INDESIT company

Model type:
R45NFEX0

Commercial code:
F028624

51920k0 Exploded views

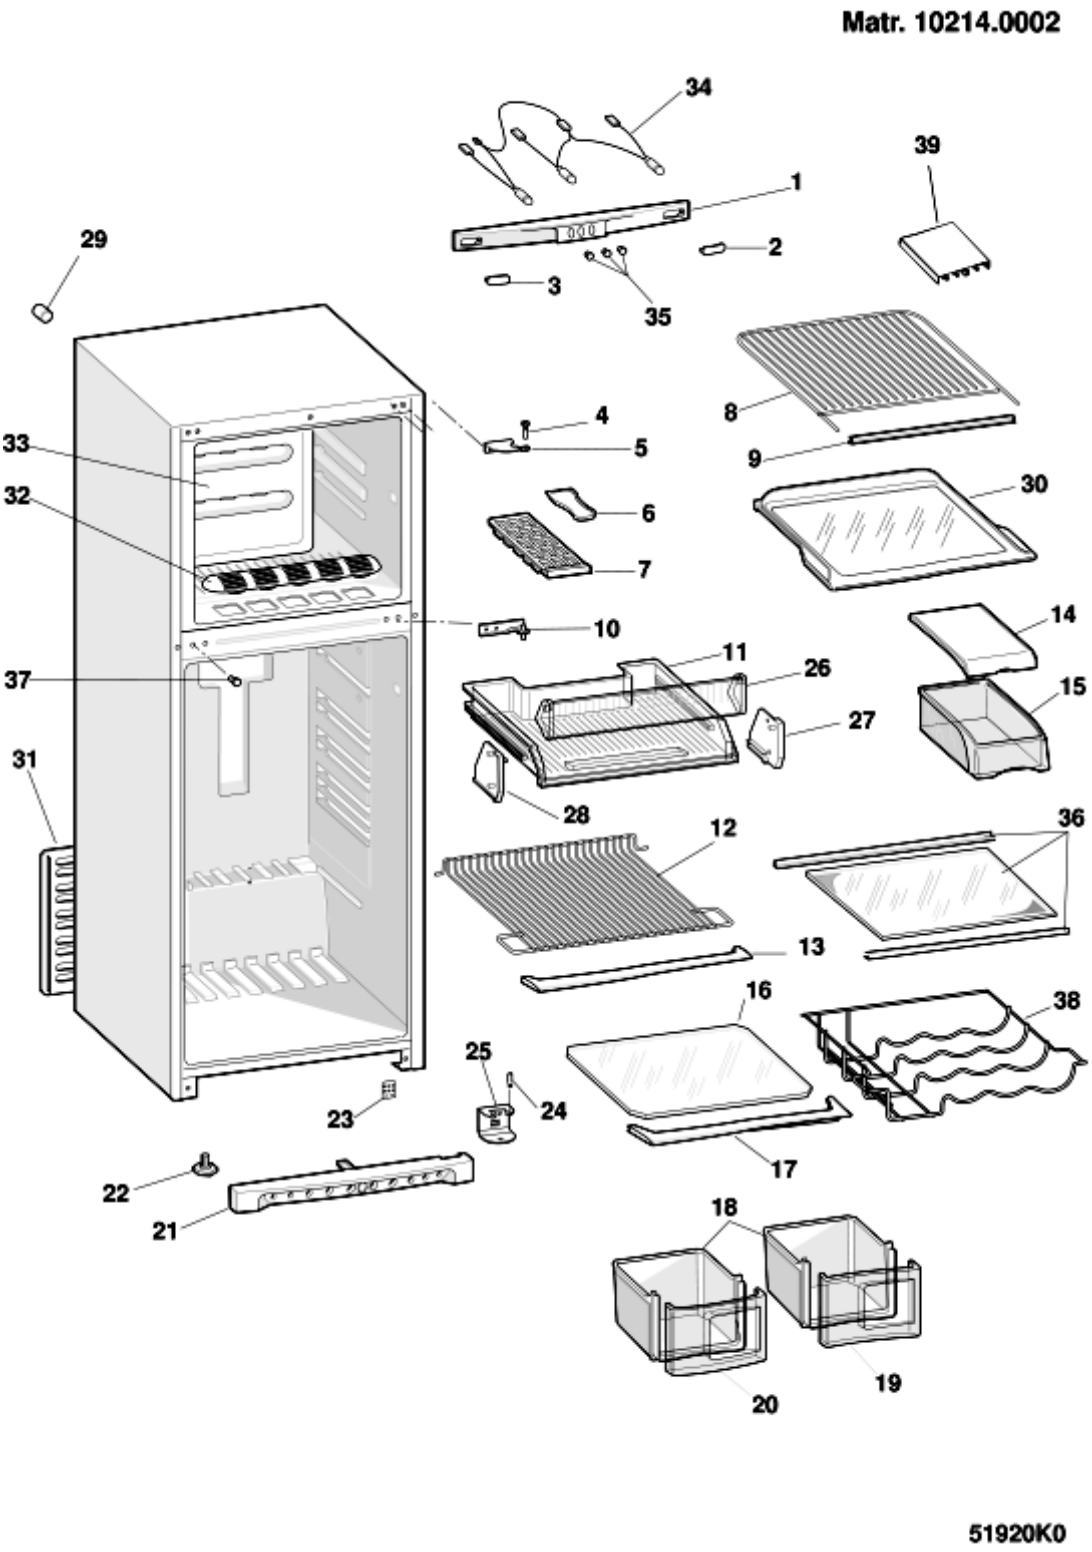
0999357: plastic compressor basement

Plastic compressor basement will be used on refrigerators since this reason adjutable foot and except single door bottom hinge have been changed. New hinge will be managed with a new code. The new bottom hinge can be used on both left and right sides.

New adjustable foot;
89682- white
89686- black

New bottom hinge assembley with adjustable foot;
110081- white
110522 - black

5192260 Exploded views

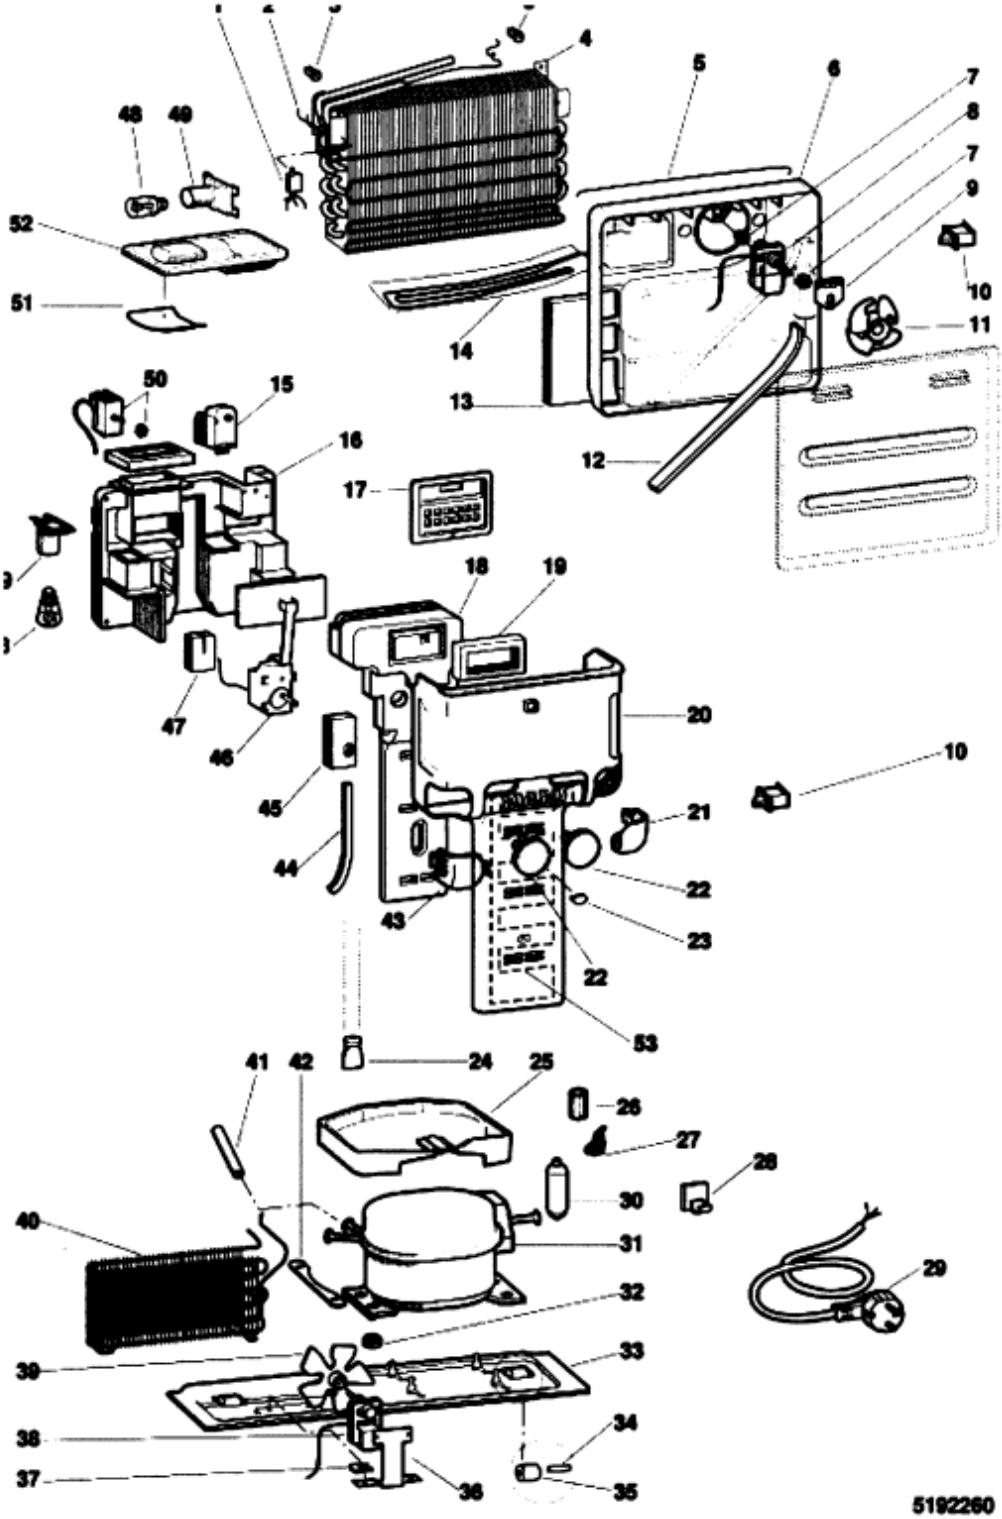
0999317: NEW EVAPORATING TRAY

After 07/11/2002 a new eavaporating tray will be used on 450lt static and 400-450lt no-frost models. In addition condenser has been changed but condenser code remain the same.

If you need to replace old evaporating tray with the new one (091975) you should oreder 4*110135 (bush) and 2*110137 (screw)

New parts:
091975- new evaporating tray
110315- fixing bush
110137- screw (4,8*50) DIN 7981 ZN/BY

0999360: modification on freezer fan motor

Since 01 July 2004 freezer fan motor has been modified to reduce noise level on no frost models that are produced in Manisa plant. (Old fan motor has grey cover, new fan motor has light green cover.) Spare part code remains the same. If you replace the

old fan motor with the new fan motor, rubber for fan has to be replaced with the new one and sponge should not be used with the new fan motor.

0999361: USAGE OF SHORT FIN EVAPORATOR ON 450LT NO FROST MODELS

Since January 2005 short fin evaporator will be used on 450lt no frost models.

old evaporator 174511
new evaporator 111112

0999372: USAGE OF 12 HOURS TIMER

From serial number 50718.0001 12 hours timer will be used instead of 8 hours timer.

new timer:
174512- TIMER SONXIE 1210

old timer:
173680- TIMER SONXIE 807
